16/01143/LBC (CT.5795/V)

**Alterations and extension to dwelling at Elmleaze Farm Westonbirt Road
Westonbirt Tetbury Gloucestershire**

Listed Building Consent 16/01143/LBC (CT.5795/X)	
Applicant:	Mr & Mrs Fitzpatrick
Agent:	LPC(Trull) Ltd
Case Officer:	Claire Baker
Ward Member(s):	Councillor Jim Parsons
Committee Date:	10th August 2016
RECOMMENDATION:	REFUSE

ELEVATIONS
AS PROPOSED

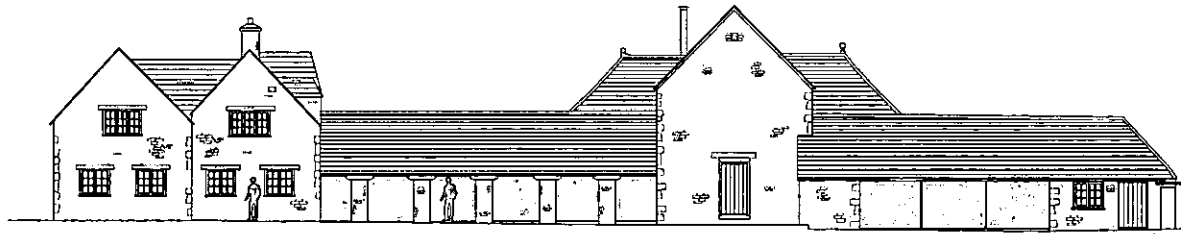
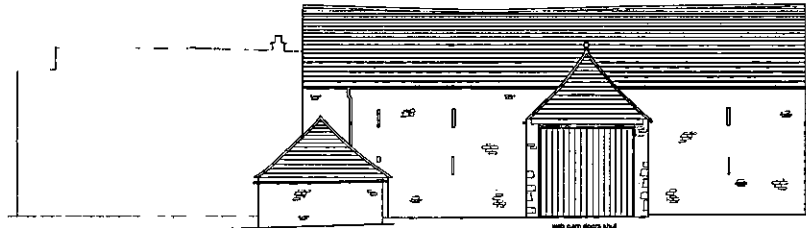
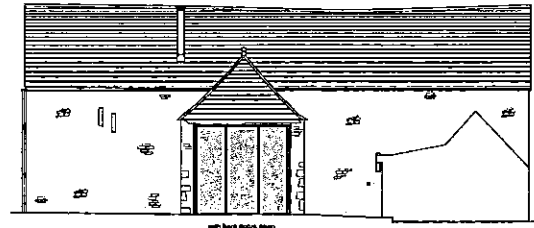
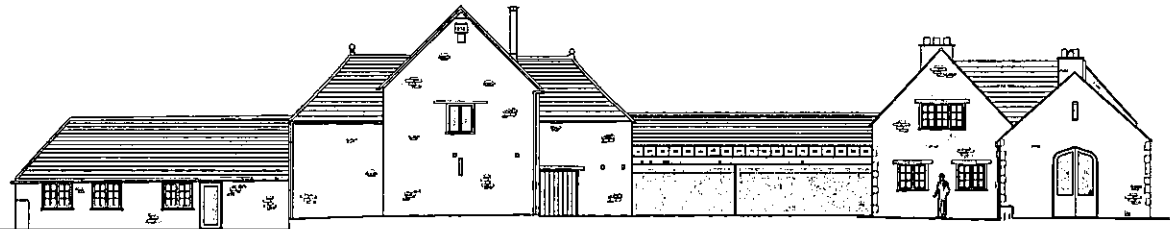
Eastern shelter shed - Introduction of glazed wall

The proposal includes the introduction of a full height glazed screen to the south elevation of the Eastern shelter shed. Officers have no objections to the removal of the existing stable doors which are not of historic interest and there are no objections in this case to the introduction of full height glazing. However, it is considered that such a glazed screen would appear as an incongruous visual departure from the vernacular context of the barn and shelter sheds. This proposal would however appear more sympathetic if the form of the opening maintained a traditional visual rhythm through the introduction of vertical elements such as oak posts. Such design details could be agreed through a suitably worded planning condition if Members were minded to grant consent.

PROPOSED ALTERATIONS
 GROUND FLOOR PLAN
 AS PROPOSED

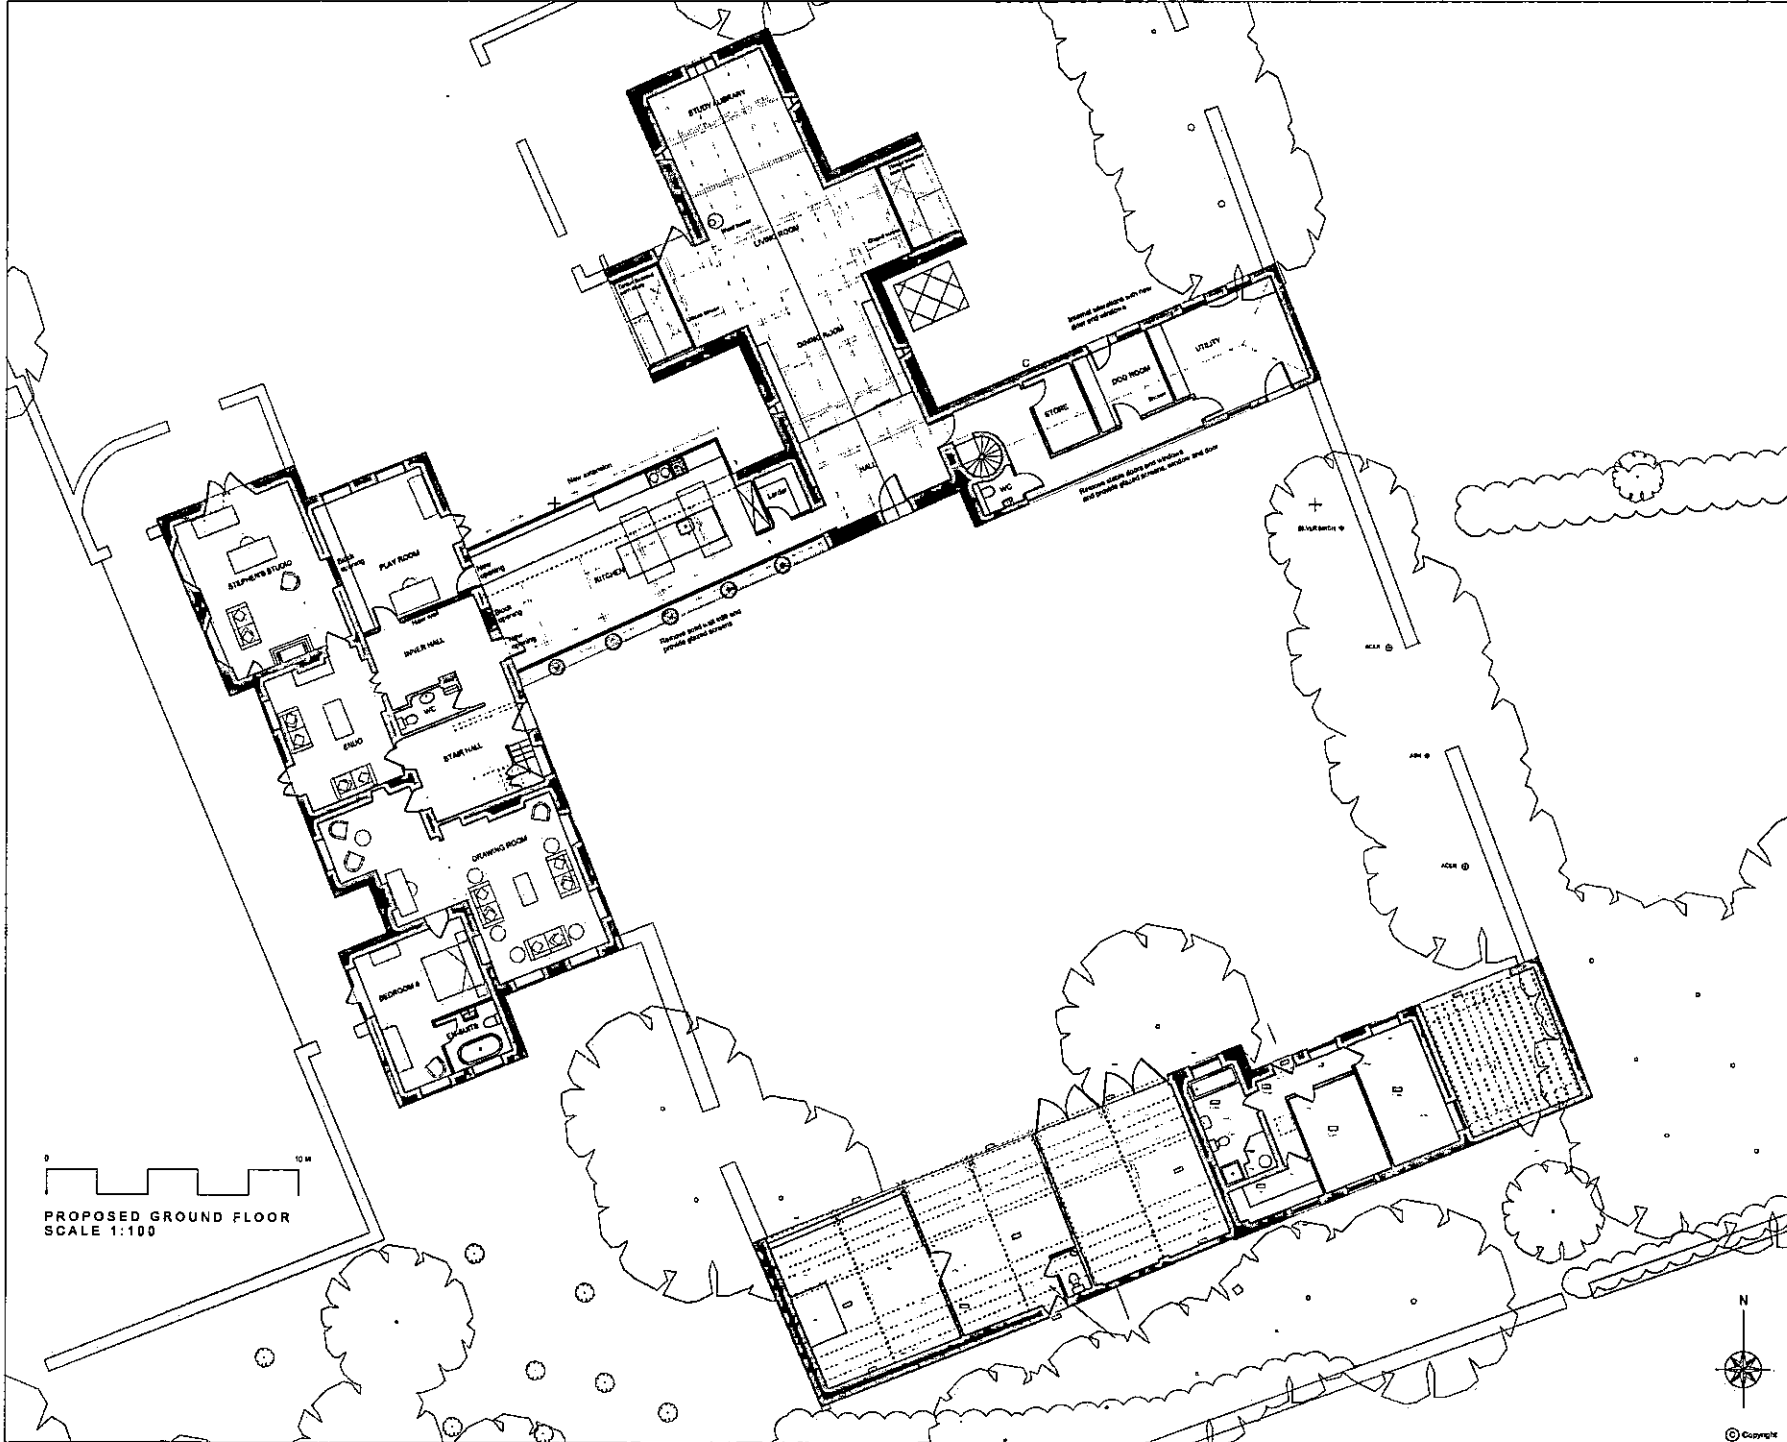
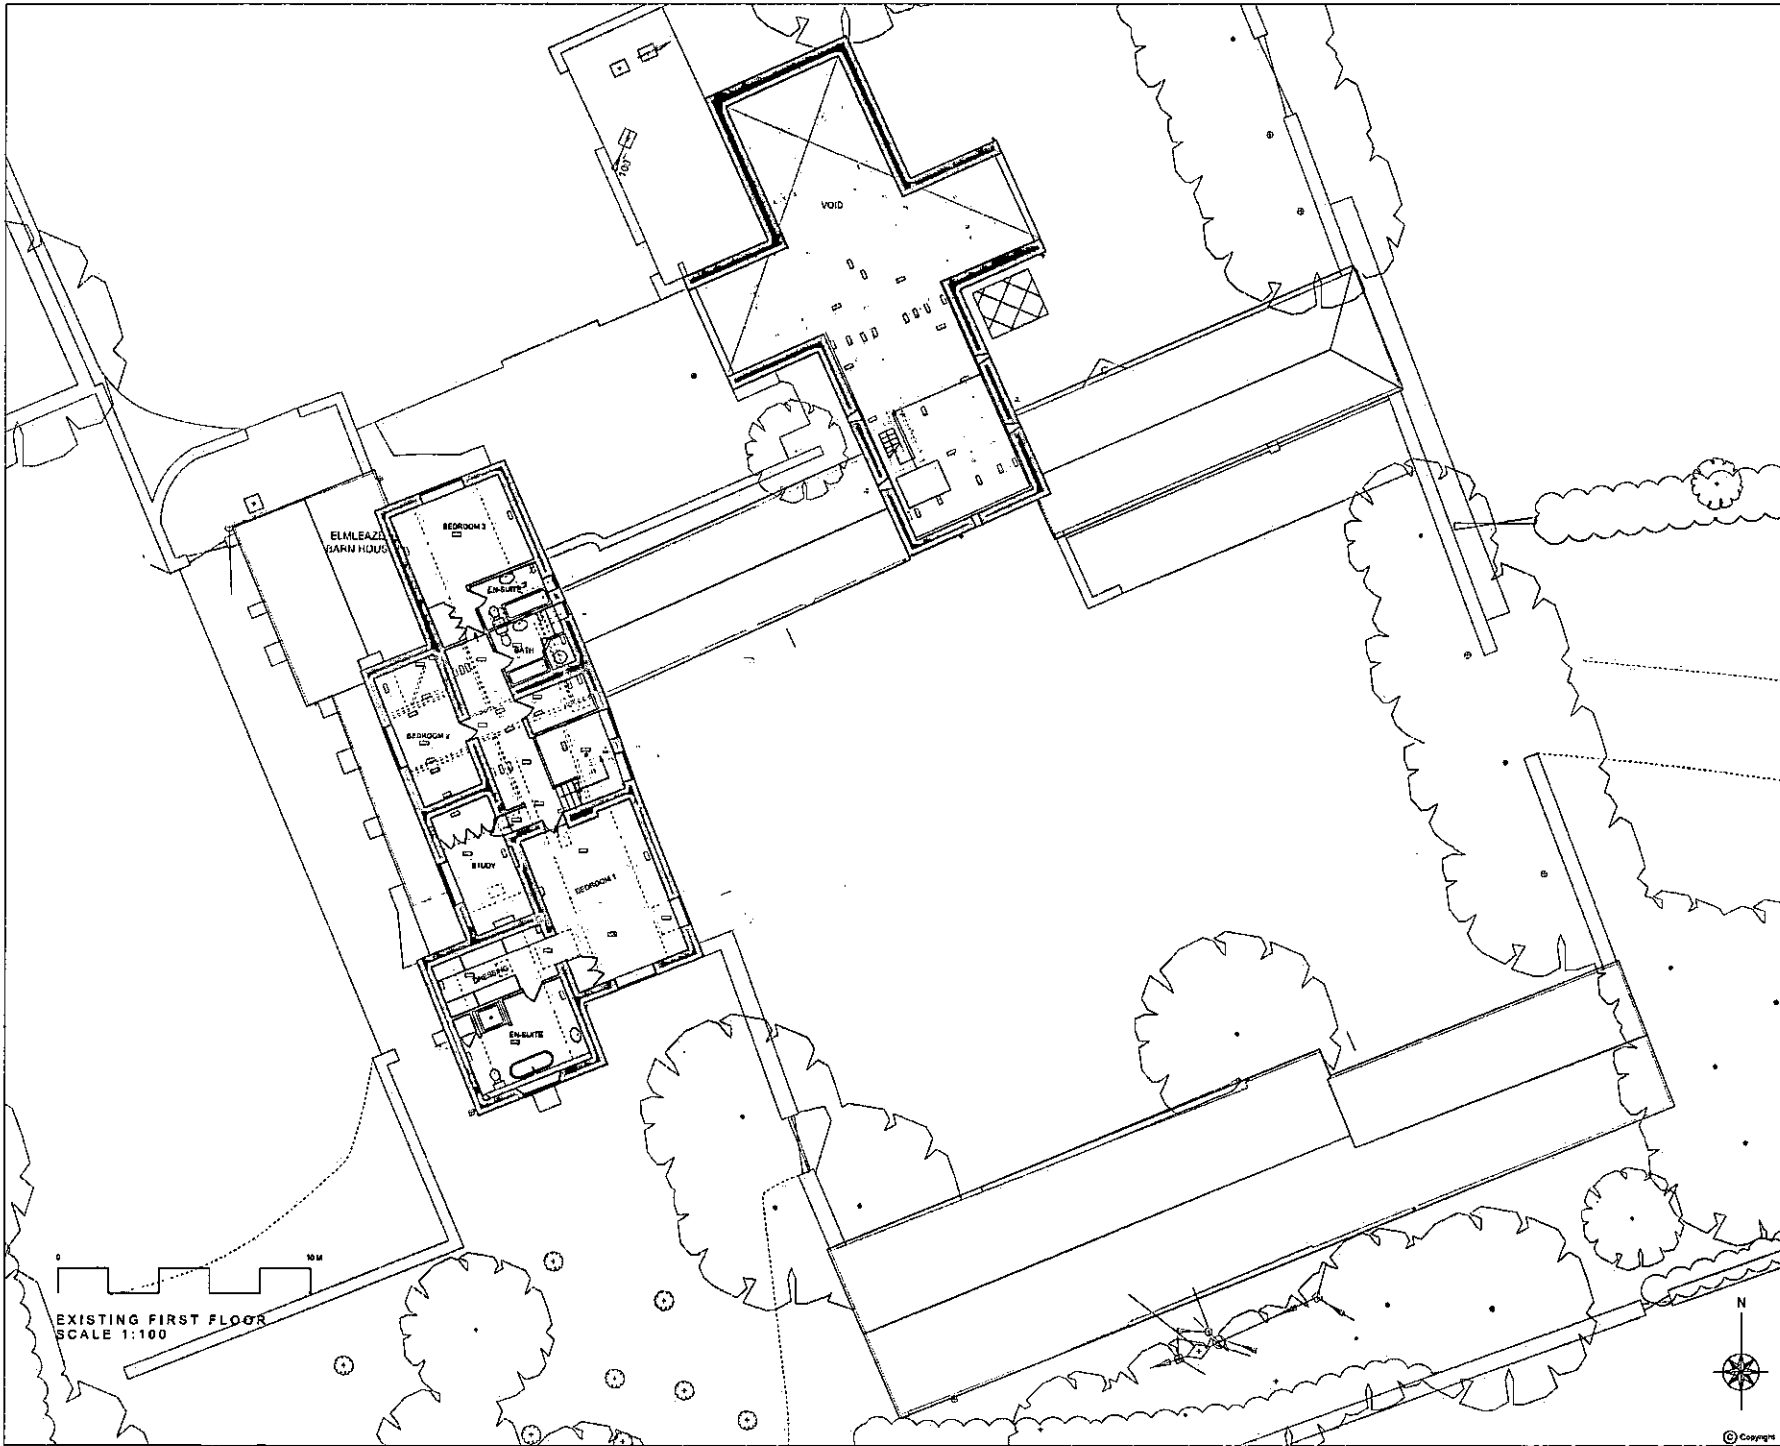
Western Shelter Shed - North Wall

The proposal is to remove a substantial section of the North/rear wall of the shelter shed, construct a structural glazed wall approximately 1.5m to the North and bridge the gap with a shallow zinc covered lean-to roof. The building has been altered over time and some areas may have been repaired or rebuilt however the form and fabric of the historic building appears to remain substantially intact and legible as the original shelter shed. Historic buildings will inevitably be altered and added to over time but this does not necessarily diminish their overall significance. The wall proposed for removal represents historic fabric which forms a strong element of the significance of the building. Furthermore its location maintains the tangible dimensions of the shelter shed which also contributes strongly to the significance of the building as a heritage asset. It is understood that the main reason for widening the shelter shed is that it is considered to be too narrow for the purposes of a kitchen which is suggested as a fundamental use of this area in order to integrate the barn and the remodelled house. However, Officers do not consider this to be a compelling reason for the demolition and relocation of the majority of the north wall of the shelter shed. Furthermore the introduction of a large area of glazing in this location would also appear incongruous within the context of the West elevation of the listed barn. It is the opinion of officers that the proposal is not necessary in order to secure the optimum viable use of the heritage asset and there would be no public benefits arising that would outweigh the harm generated by the proposal.

It would remove a substantial section of historic stone wall forming a fundamental component of the original shelter shed resulting in the loss of historic fabric.

The historic form and proportions of the original shelter shed would be obscured and rendered illegible by the moving of the wall out to a new position resulting in a dilution of the vernacular integrity of the original building form.

The historic appearance of west elevation of the listed barn and its interaction with the shelter shed would be wholly altered in character by the changes, including the structural glass wall, resulting in a negative visual impact upon the listed barn.

This element of the proposal has been the subject of extensive pre-application advice during which Officers have consistently advised that the proposal would not be supported. Officers consider that some form of modest opening in the wall may be supported if the impact upon the appearance and physical fabric is limited and the wall remains substantially intact. Officers considered that there is sufficient scope within the footprint of the existing house to arrange accommodation which provides a view of the garden to the north if required without alteration of the wall of the shelter shed.
